Ohio Department of Natural Resources
DNR-250014 Mary Jane Thurston State Park Tree House Cabins
1466 State Route 65, McClure OH 43534, Wood County

ADDENDUM 01

Date of Addendum: 12/19/2025

FIXTURE HEIGHT

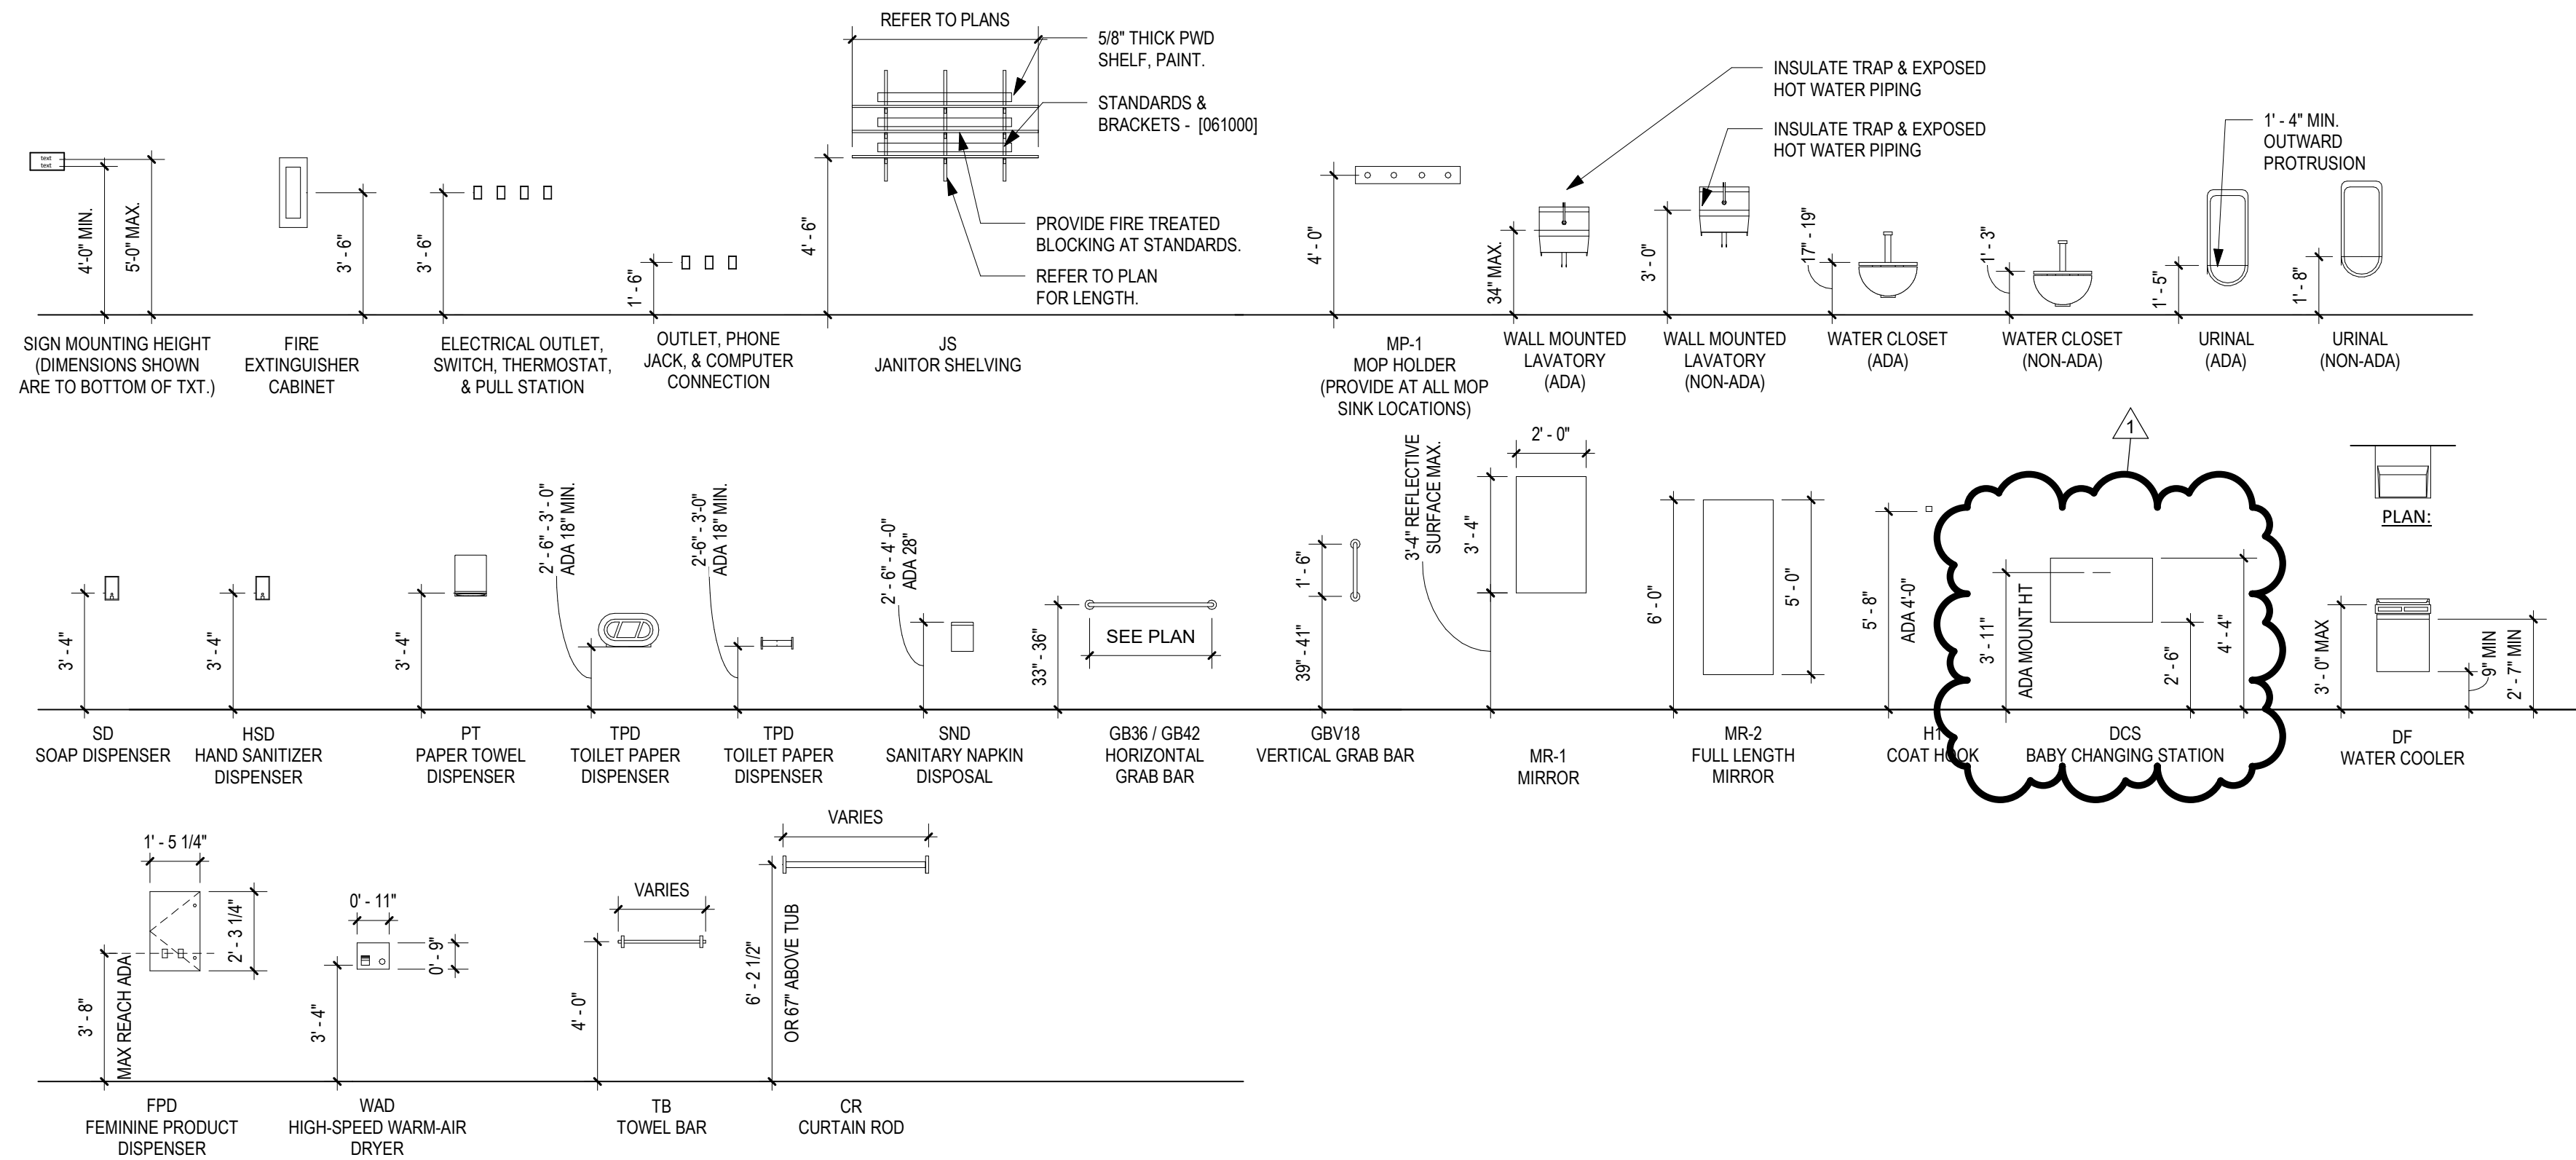
1. Sheet 34 – ARCHITECTURAL ABBREVIATIONS, SYMBOLS, & NOTES
 - A. Fixture Height legend – revise dimension height of DCS BABY CHANGING STATION
2. Sheet 46 – SHOWERHOUSE – RCP
 - A. Drawing 1 and 2 – Add Room Tags to all rooms as indicated
 - B. Drawing 2 – Revise ceiling height tags as indicated
